TVHS Murfreesboro - Replace Chiller and Cooling Tower VA Project # 626A4-14-201 Addendum #1 05-26-2016

This Addendum, dated 5-26-2016, serves to clarify, revise, and supersede information in the Project Manual, Drawings, and previously issued Addenda. Portions of the Addendum affecting the Contract Documents will be incorporated into the Contract by enumeration of the Addendum in the Owner/Contractor Agreement.

REVISIONS TO DRAWING SHEETS:

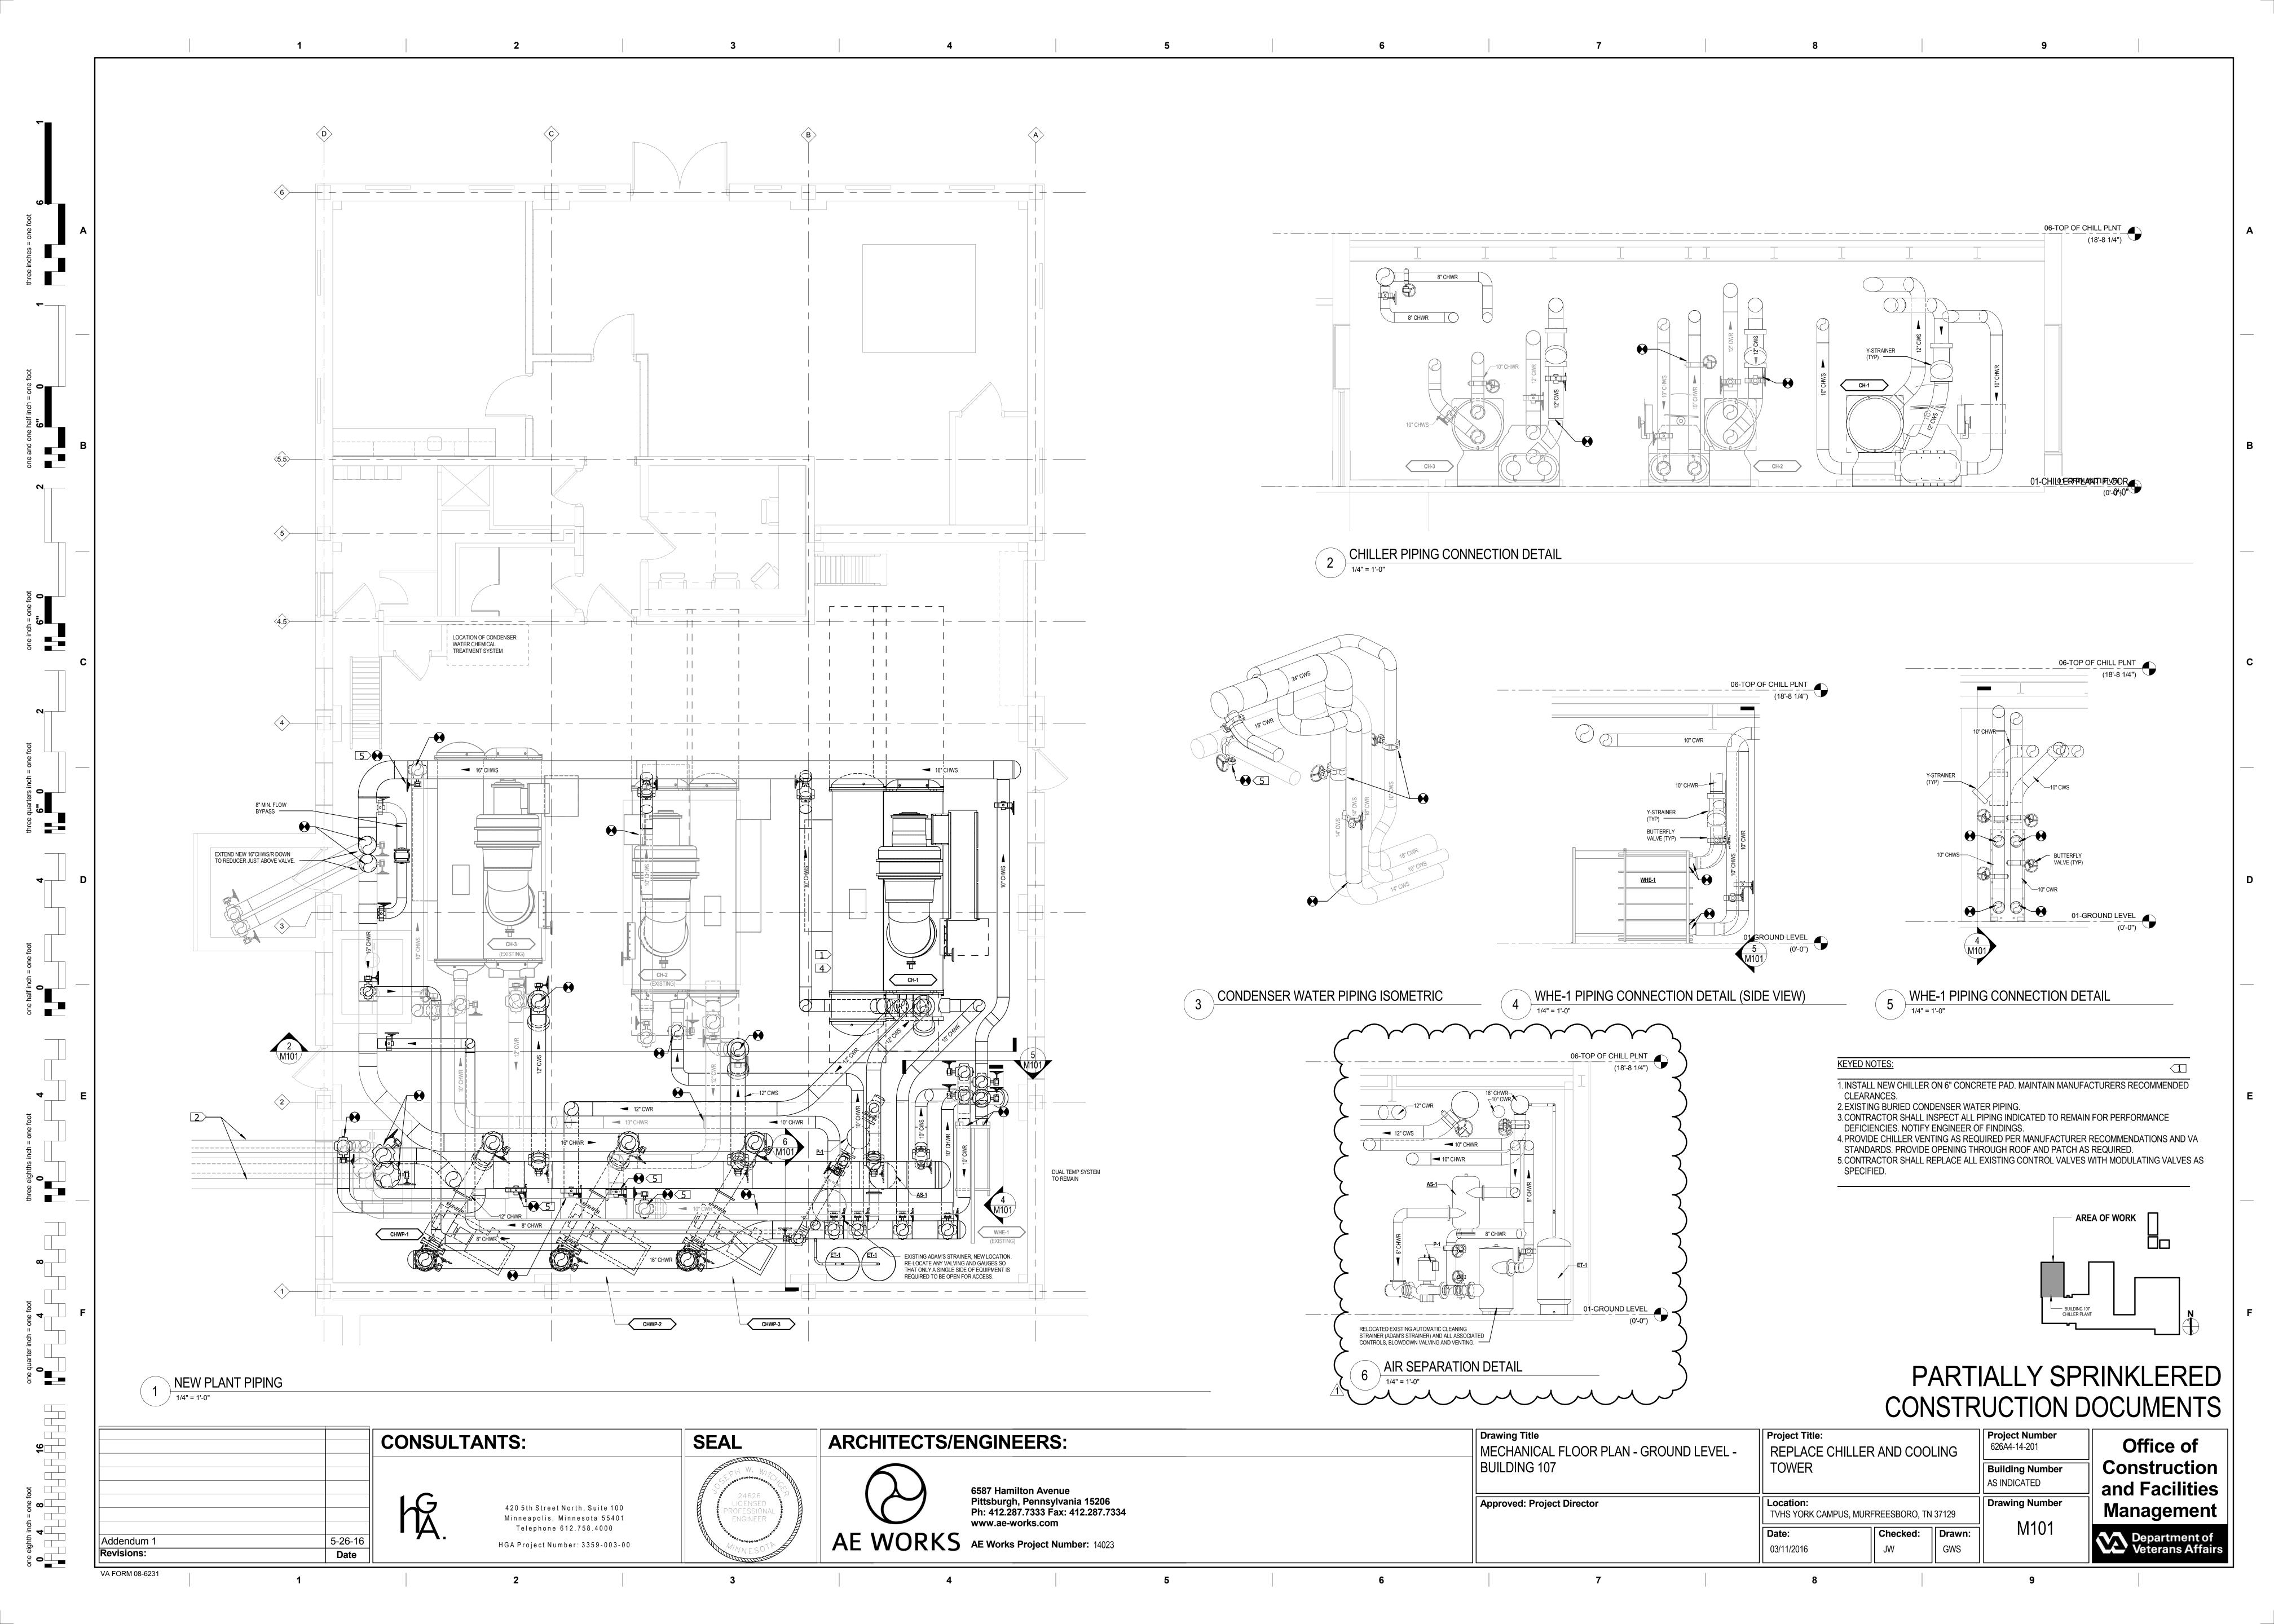
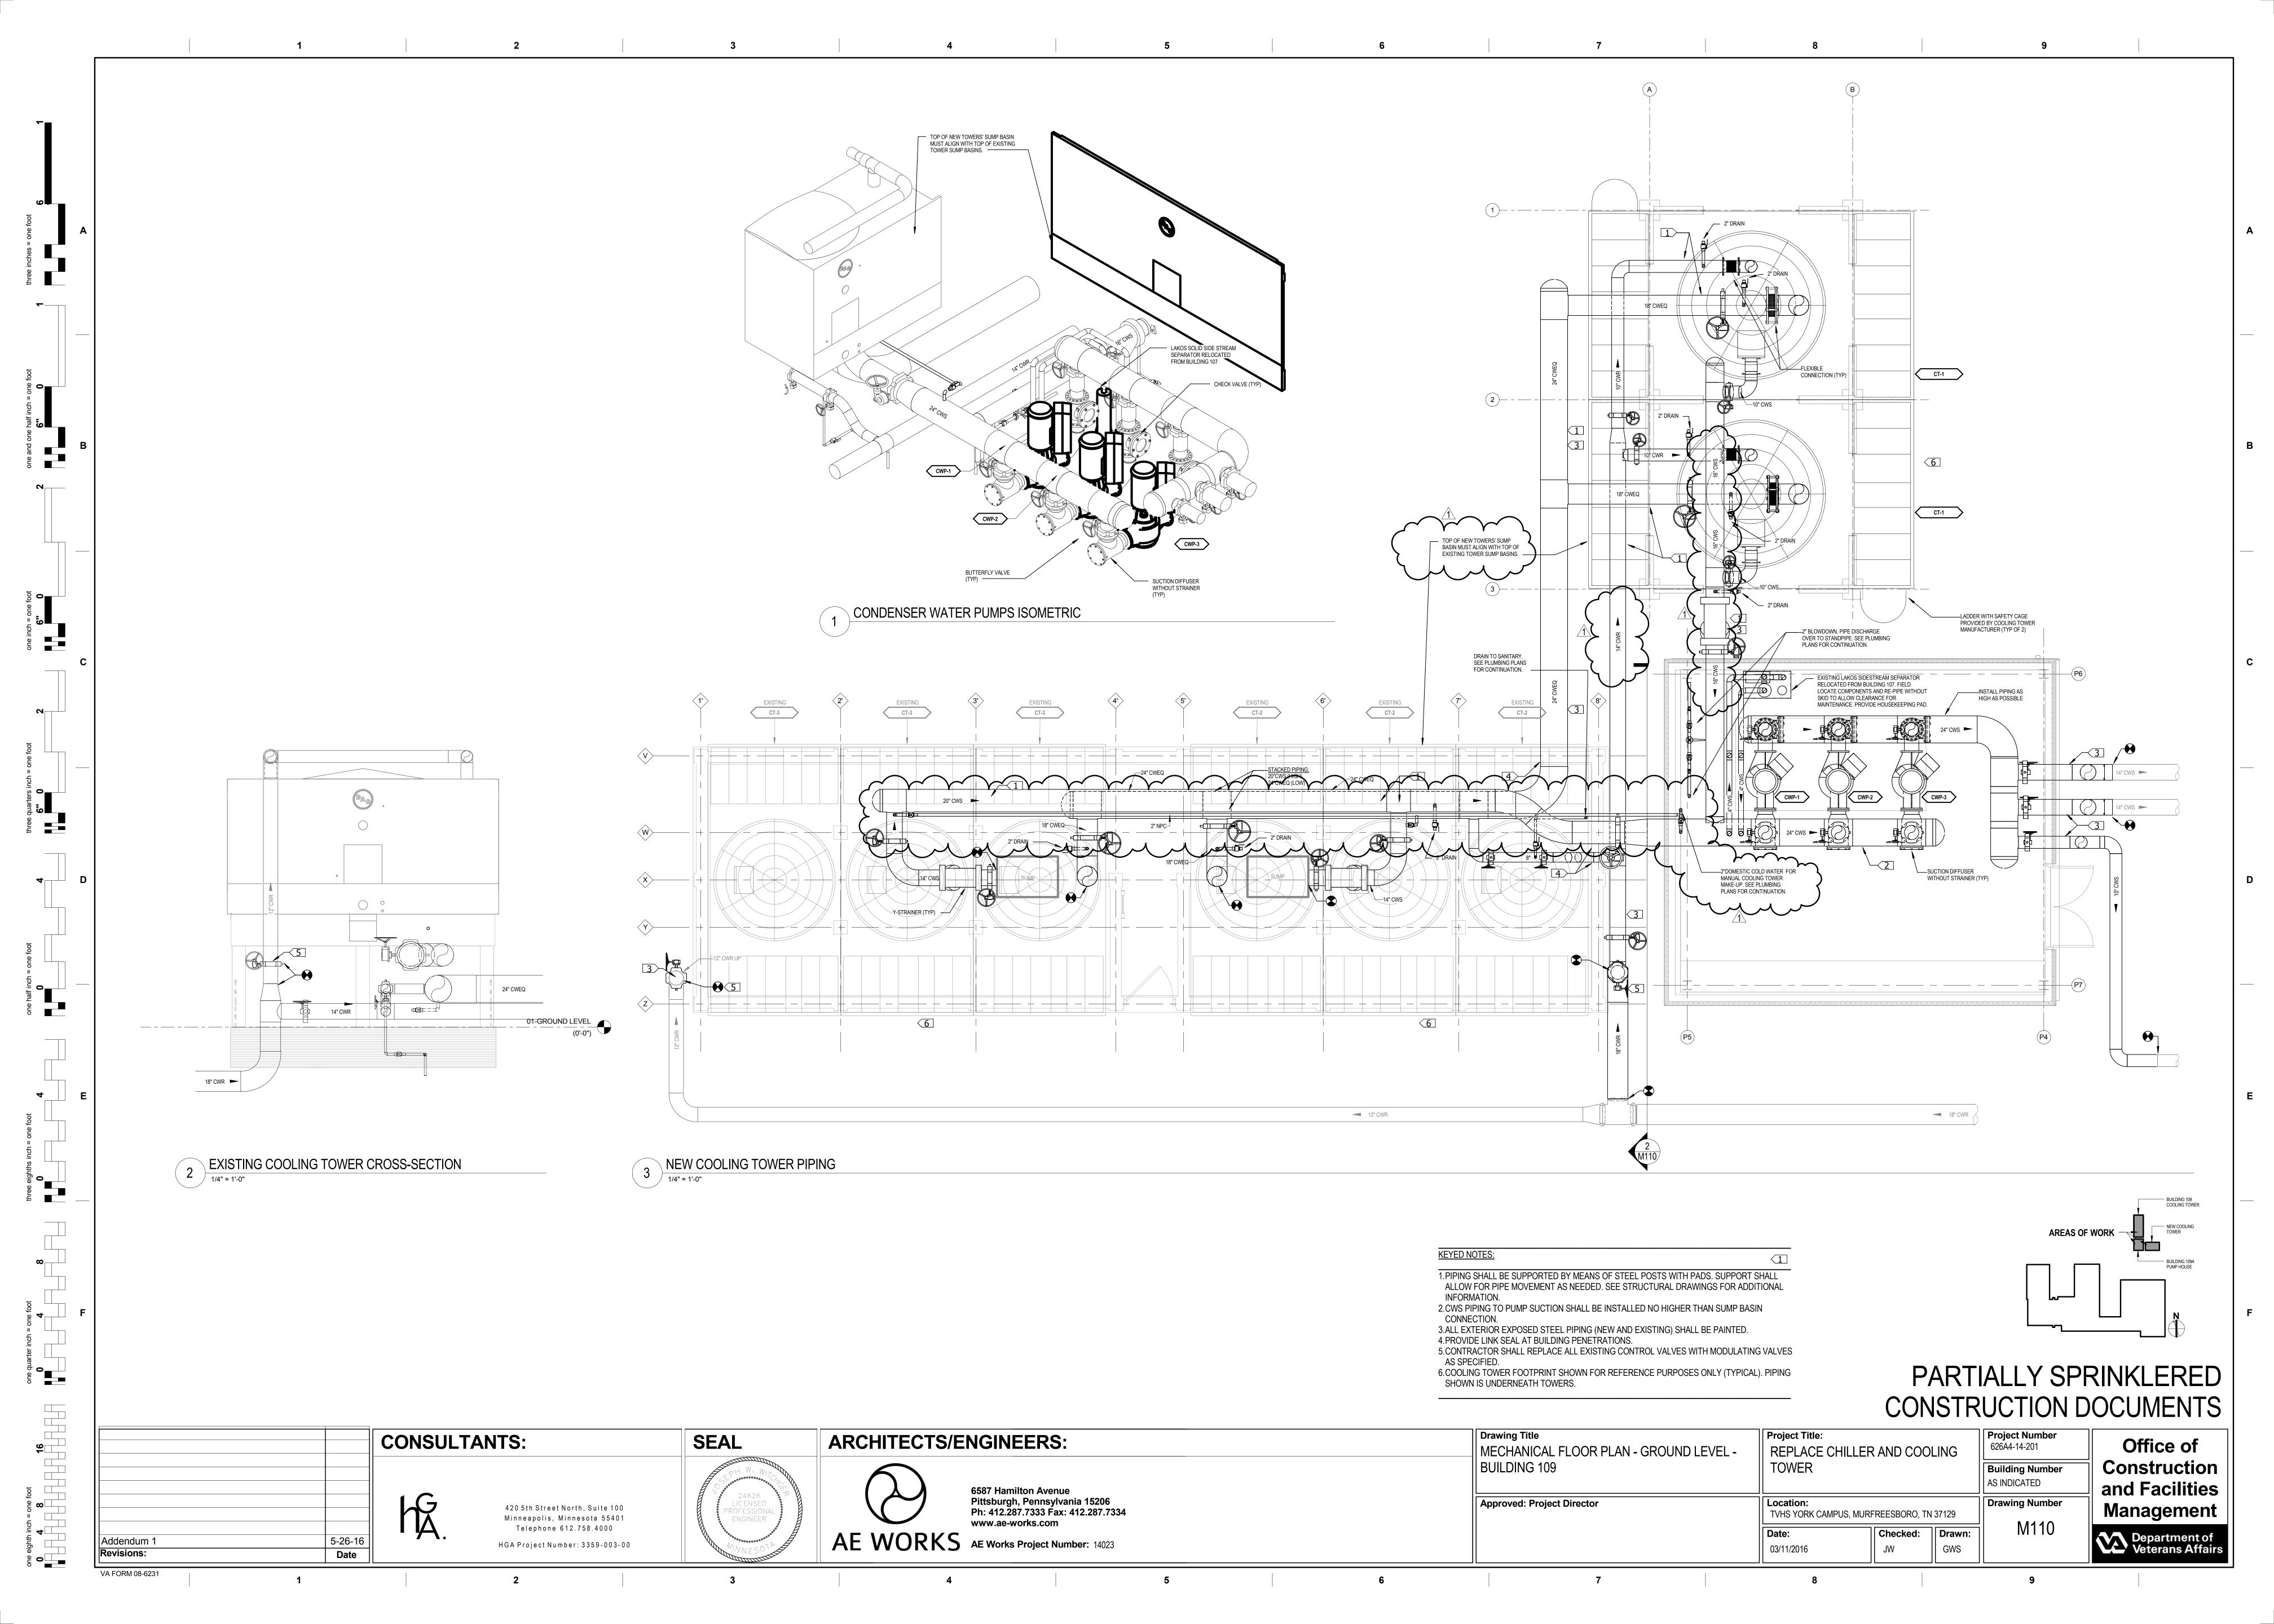
1. Relocated Adams strainer includes relocating drains, controls identified on plans. Clarification of new air separator and piping made to 6/M101.

- 1. Top of new cooling tower sumps must be equal to top of existing cooling tower sumps. See added note to document.
- 2. New reducer may be required depending on location of buried 18x12 reducer underground at towers. Contractor to field verify.
- 3. Modification of flexible metal shielded expansion devices will be used at towers. Change shown on drawing.
- 4. CWR and CWS pipe sizes switched. Piping shown as 14" CWR and 16" CWS on drawing.
- 5. Manual water make up shown on schematic (M601) added to drawing.

- 1. Installation of equipment must be installed in accordance with manufacturer's requirements. Changes to details for compliance shown.
- 2. Refrigerant venting depends on chiller selected. R-123 chiller shall use Trane Rupture Guard safety valve. See detail 9/M500 for revised requirement.

3. Snubbers are not required at pressure gages as called out, utilize ½" ball valves as shown on details.

- 1. Air separator to include auto air vent isolated by manual ball valve, drain with blowdown valve.
- 2. Modifications to match changes made to plan and details.

1. Modify cooling tower schedule as shown. Equipment TOTAL NOMINAL CAPACITY does not change, number of cells and flow per cell updated to match actual.
